Case Number: R18013

CASE COMMENTS:

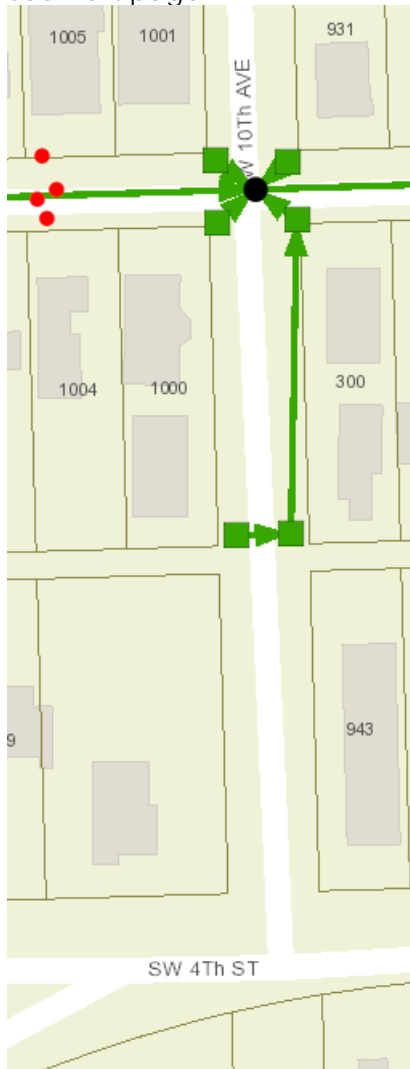
- a) The applicant shall use Broward County's latest [Plate WM 2.1 - Future Conditions](#) for determining the average wet season ground water levels to evaluate if demolition or excavation/earthwork will require dewatering activities. The Plate WM 2.1 – Future Conditions average wet season
